Subject ▶ Change on handle, blade case, strain relief, etc.

For Models ▶ 2412N, 2414, 2414K (Portable Cut-off)
5103N, 5103NA, 5201N and 5201NA (Circular Saw)

For 2412N, 2414 and 2414K

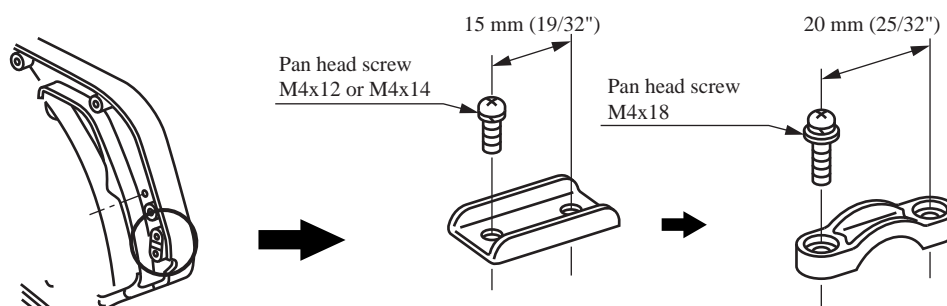
Description ▶ * The pitch between the screw holes for securing the strain relief will be changed from 15 mm (19/32") to 20 mm (25/32").
* For 2412N, 2414 and 2414K only
The pan head screws M4x18 will be replaced by tapping screws PT4x18.
For 5103N, 5103NA, 5201N and 5201NA only
The pan head screws M4x12 or M4x14 will be replaced by pan head screws M4x18.

The shape of strain relief is different depending upon the kind of power supply cord to be secured.

1. Re: Handle set, screw and strain relief for 2412N, 2414 and 2414K The current type parts and the new type parts are interchangeable as a set.
2. Re: Blade case, screw and strain relief for 5103N, 5103NA, 5201N and 5201NA
The current type parts and the new type parts are interchangeable as aset.
